UNITED STATES PATENT AND TRADEMARK OFFICE

10/710,401

Office Action Summary

DETAILED ACTION

FIG. 9

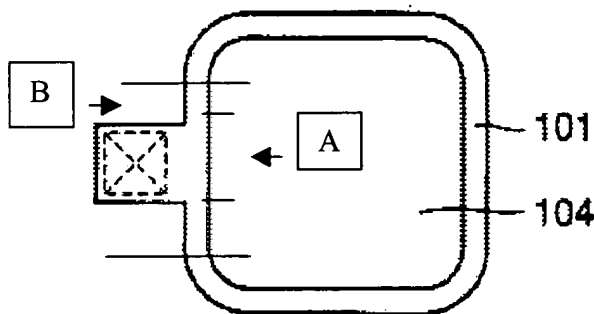
Regarding claim 1, Harada et al. discloses in e.g., Fig. 3 and Fig. 9 a chip structure, at least comprising:

- a chip (structure in e.g., Fig. 1B), having at least a bonding pad (101; column 18, line 23) and a transmission line (100; column 18, line 19) on a chip surface,

- wherein the transmission line (100) is coupled to the bonding pad; and
- a passivation layer (102 and 103; column 18, line 63 – column 19, line 4), covering the chip surface,
- wherein the passivation (102 and 103) has an opening (104; column 19, line 4) to expose the bonding pad (101),

- wherein a cross-section of the opening (104) includes
 - o a straight line (A or B in Fig. 9) and an arc (the other portion except the “A” or “B” portion. Since the definition of “arc” includes a continuous portion of a curved line, the other portion except the “A” or “B” area read as an “arc”) connecting to two ends of the straight line, and
 - o the straight line is near to a connection terminal between the transmission line and the bonding pad (see e.g., Fig. 9).

Regarding claim 2, since the length of the straight line (A) is smaller than the half of the total length of the opening 104, the straight line of Harada et al. fully meets the claimed limitation.

Regarding claim 3, since the length of the straight line (B) is bigger than the half of the total length of the opening 104, the straight line of Harada et al. fully meets the claimed limitation.

Regarding claims 4 and 10, Harada et al. discloses in e.g., Fig. 9 the passivation layer (102 and 103) including an organic passivation layer (polyimide; column 19, lines 1 – 4).

Regarding claims 5 and 11, Harada et al. discloses in e.g., Fig. 9 the passivation layer (102 and 103) including an inorganic passivation layer (SiO₂; column 18, lines 63 – 67).

FIG.50

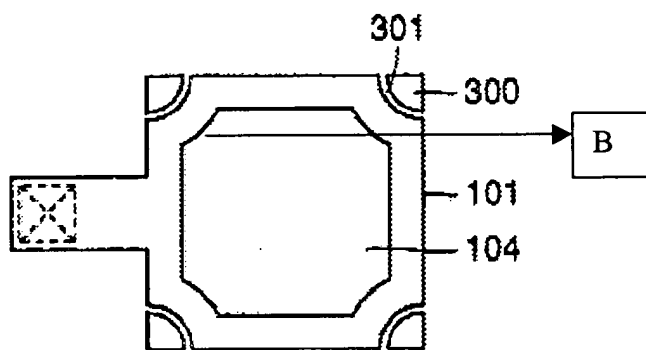
Regarding claim 6, Harada et al. discloses in e.g., Fig. 3 and Fig. 50 a chip structure, at least comprising:

- a chip (structure in e.g., Fig. 1B), having at least a bonding pad (101; column 18, line 23) and a transmission line (100; column 18, line 19) coupled to the bonding pad,

- wherein the bonding pad (101) and the transmission line (100) are on a chip surface;
and
- a passivation layer (102 and 103), covering the chip surface,
- wherein the passivation (102 and 103) has an opening (104) to expose the bonding pad (101),
- wherein a cross section of the opening (104) includes
 - a curving line (B in Fig. 50) and an arc (any other curved portion except the “B” portion) connecting to two ends of the curving line,

- wherein the curving line is concave to the arc and near to a connection terminal (105; see Fig. 4) between the transmission line (100) and the bonding pad (see e.g., Fig. 50).

Regarding claim 7, Harada et al. discloses in e.g., Fig. 50 each point of the curving line has a “substantially” equal distance to the connection terminal between the transmission line and the bonding pad.

Regarding claim 8, Harada et al. discloses in e.g., Fig. 50 a curvature of the curving line being less than or equal to a curvature of the arc.

Regarding claim 9, Harada et al. discloses in e.g., Fig. 50 a curvature of the curving line being greater than or equal to a curvature of the arc.
